POLICY REPORT
DEVELOPMENT AND BUILDING

Report Date: February 6, 2014
Contact: Kent Munro
Contact No.: 604.873.7135
RTS No.: 10423
VanRIMS No.: 08-2000-20
Meeting Date: February 18, 2014

TO: Vancouver City Council
FROM: General Manager of Planning and Development Services
SUBJECT: CD-1 Rezoning: 458-476 West 41st Avenue

South (6-storey Building) Elevation

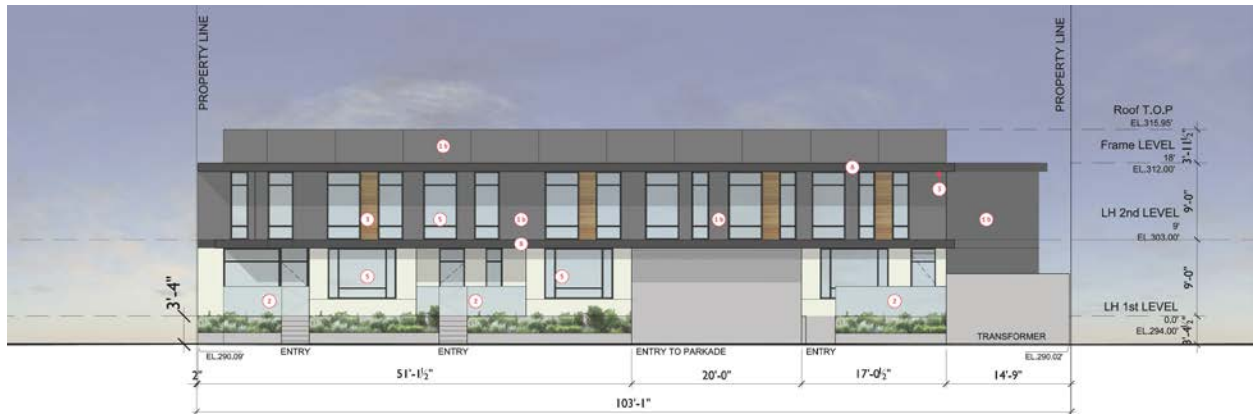
2. Design development to the upper storeys facing south to reduce their apparent visual scale.

4. Provision of a more notable setback at the fifth storey;

5. Design development to mitigate privacy and overlook issues to other residential properties.

Note to Applicant: Consider the use of materials, detailing, colour and composition to reduce the visual weight of the top levels and to introduce a distinctive change of expression from the middle of this façade.

Note to Applicant: This can be accomplished providing a 2.4 m (8 ft.) set back.

Note to Applicant: This can be accomplished by further development of landscape drawings, enlarged sections and other drawings that illustrate specific built features that will balance access to natural light with privacy concerns.
